PLANNING DEPARTMENT STAFF REPORT AND FINDINGS

ROLLING MEADOWS MINOR PARTITION – PRELIMINARY PARTITION APPROVAL (File MP 23–11)

Preliminary Partition Plan Map

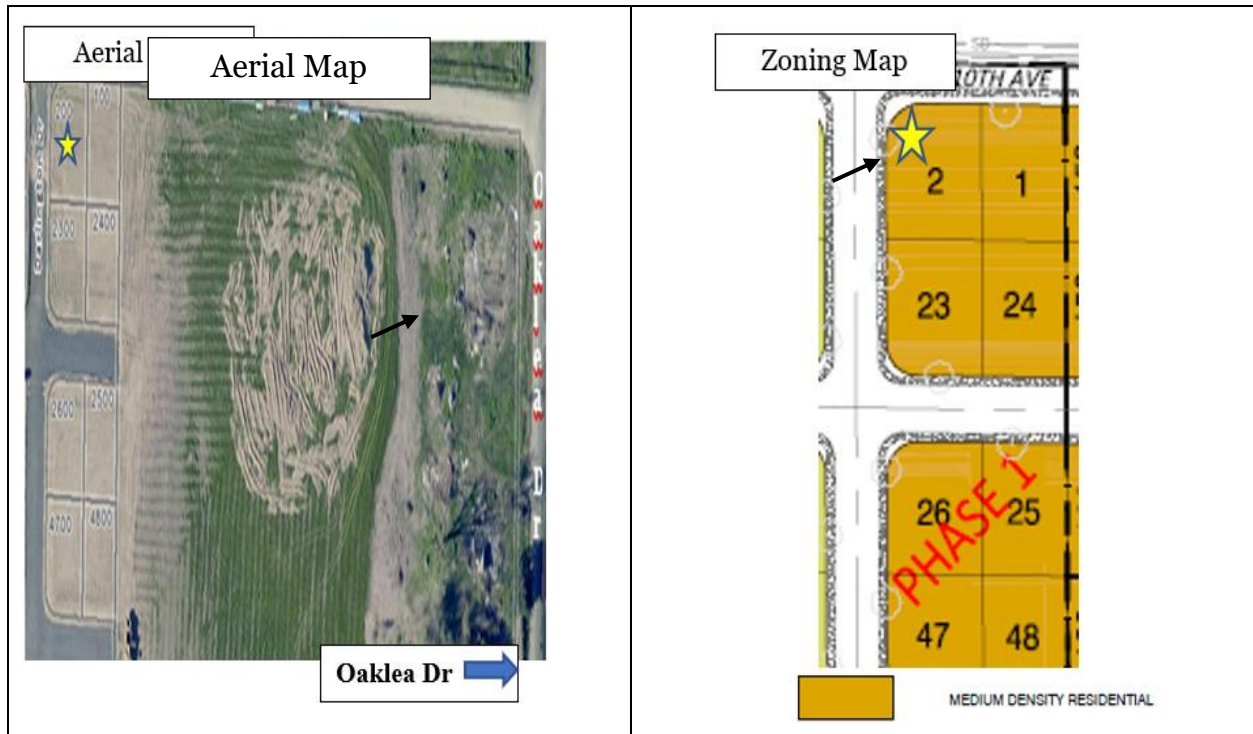
Finding 7: The preliminary plan has the dimensions of both parcels. The final plat must have this information.

Finding 9: The preliminary plan has the date, north point and scale of the drawing. The demensions of the property are adequately identified as adjacent tax lots are identified and numberd. The legal description of the property is Lot 2, Rolling Meadows PUD Phase 1. Neither

the preliminary partition plan nor the supplemental materials identify the assessor's account number (Act #1914516).

Finding 10: The name and address of the owner/partitioner is present on the preliminary plan and its telephone number. However, the telephone number is included on the application form. The applicant's representative's name and address is listed on the preliminary plan as is Marcus Cross, the applicant's surveyor.

Finding 12: The preliminary plan depicts the layout of the proposed parcels and their number. The complete dimension of each parcel is included and their square footage.

Finding 14: The preliminary plan shows the location of two dedicated water easements and a public utility easement. These easements were dedicated as part of the approval of Phase 1 of the Rolling Meadows Subdivision.

Finding 33: The preliminary plan shows a 10' wide utility easement.

Finding 39: The proposed parcels are large enough for their intended residential use for attached single-family dwellings. However, because the lot widths will be 34 feet, it is recommended that the parcels share a driveway when developed.

Condition of Approval #1: The final plat must show all easements. All easements must be recorded and the public utility easements dedicated to the City prior to final plat approval.

Condition of Approval #2: Because of the narrow width of the lots, the parcels must have a shared driveway when developed.
